No. EL/3.1.35/2 Electrical

**MODIFICATION SHEET NO. RDSO/2011/EL/MS/ 0403 (Rev.0) , Dated 30.11.11**

Auto switching of machine room/corridor lights to avoid draining of batteries in three phase electric locomotives.

# Annexure-I

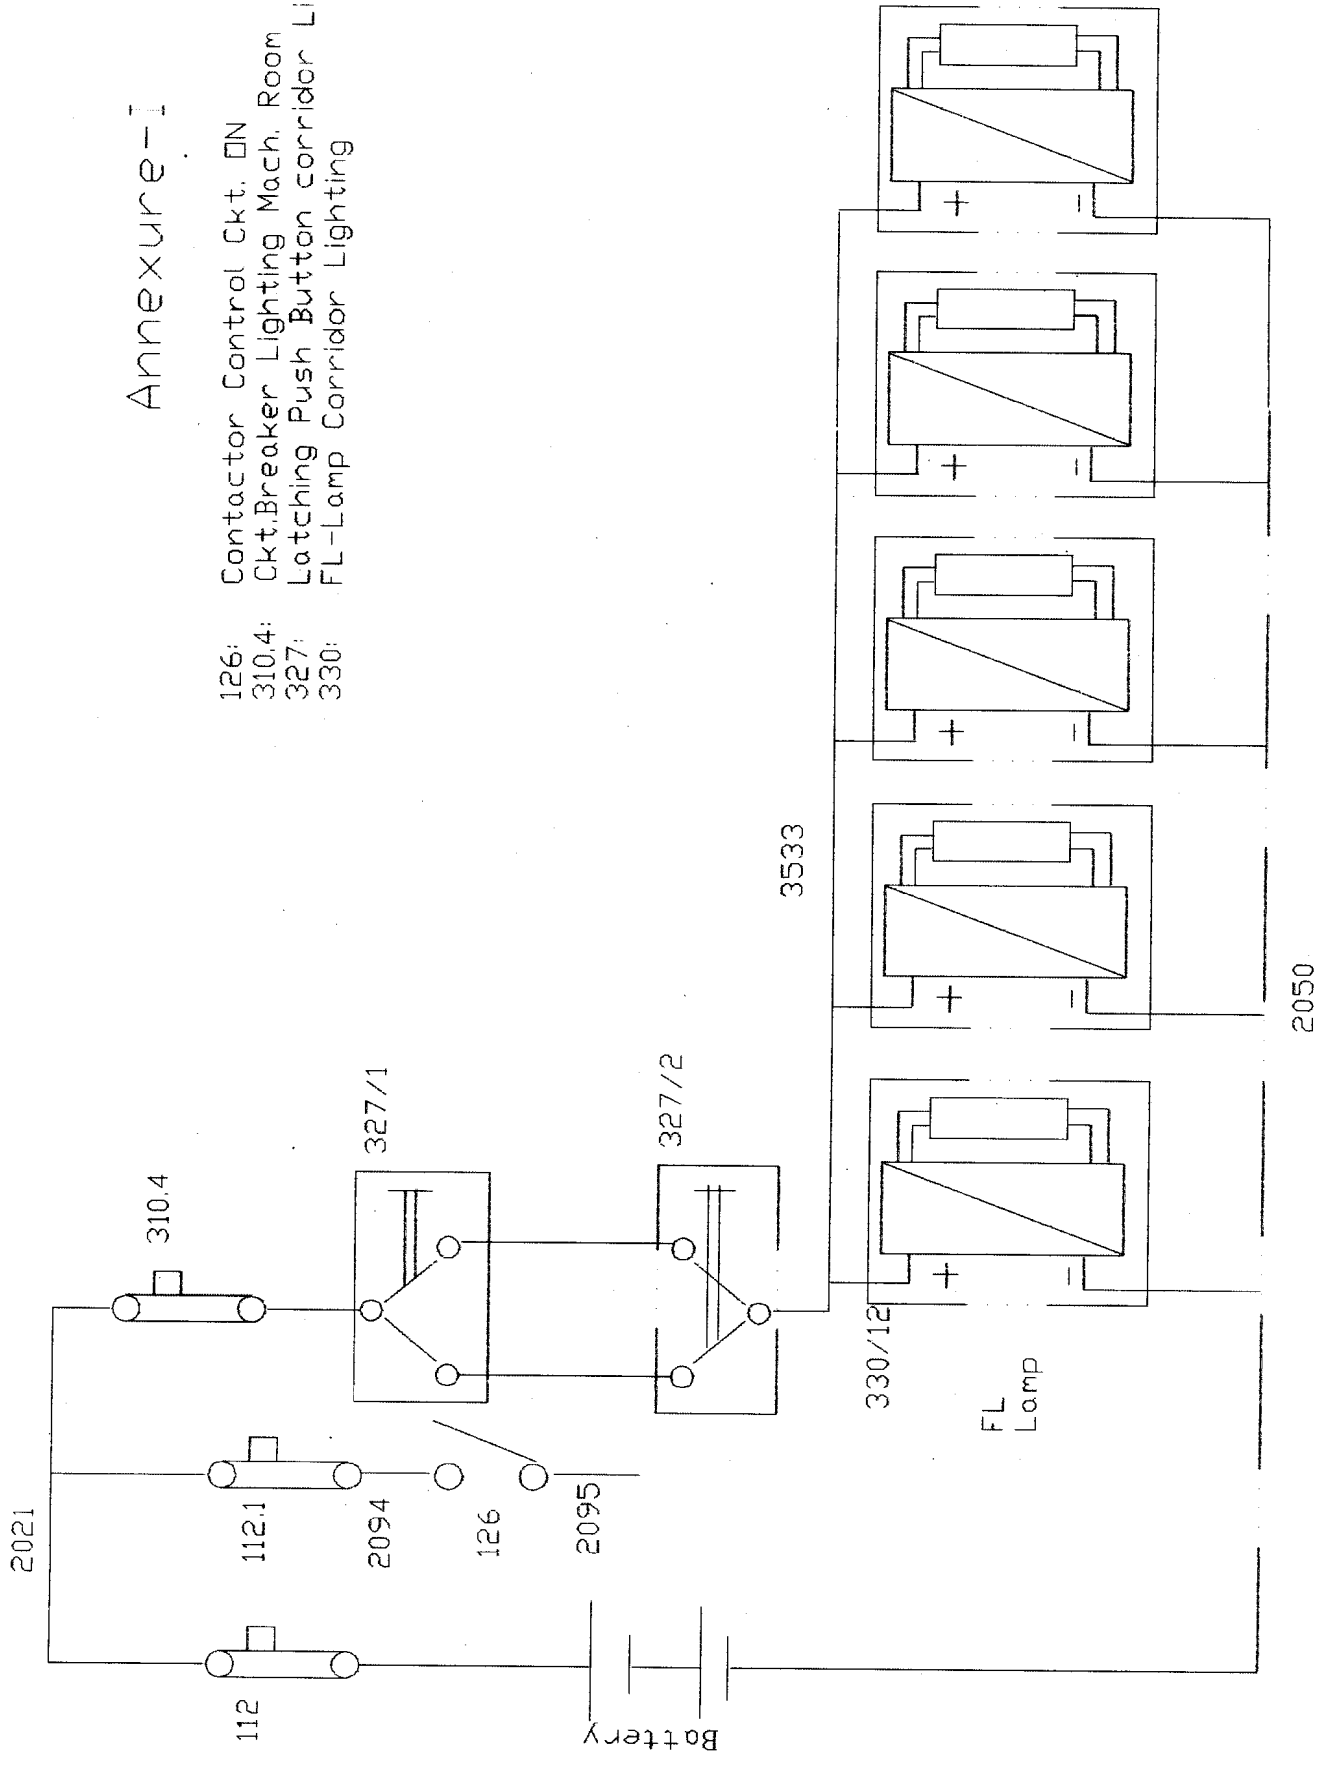
The corridor light and cab light are directly connected to battery through MCB 310.4. Corridors light and cab lights remains "ON" after the MCE "OFF" or the locomotive is shutdown. To avoid this circuit is modified, so that the machine room light and cab lights gets switched off automatically after a delay of 10 minutes even if MCE is "ON" after the locomotive is shutdown.

As per ABB doc. No. 3EHP281144 sheet no.04B and 3EHP281147 sheet no 07A of G1. The circuit diagram is indicated as annexure-I.

- 4.1 The modified circuit diagram is indicated in annexure-II. As per modified circuit "Cable no 2021 at MCB no. 310.4 is to be removed and to be connected after Contactor 126 (control electronics ON) i.e. at cable no.2095.

- 4.2 Implementation of above modification will require BL key to be put in 'Driving' position or in 'Cooling' position for cab and machine room light to get 'ON'. However this may pose problem in resetting of MCB or doing some trouble shooting in machine room after switching off electronics as machine room light and corridor light will also get switched off. In order to overcome this situation drivers are required to be instructed that to examine machine room BL, key should be kept in driving mode or in cooling mode and for resetting of MCB or for doing some trouble shooting in machine room the BL key should be put in cooling mode again after switching off the electronics with following sequence so that contactor no.126 gets closed and contactor no.218 does not close in cooling mode

**Driving → Off → Cooling → Off → Cooling**
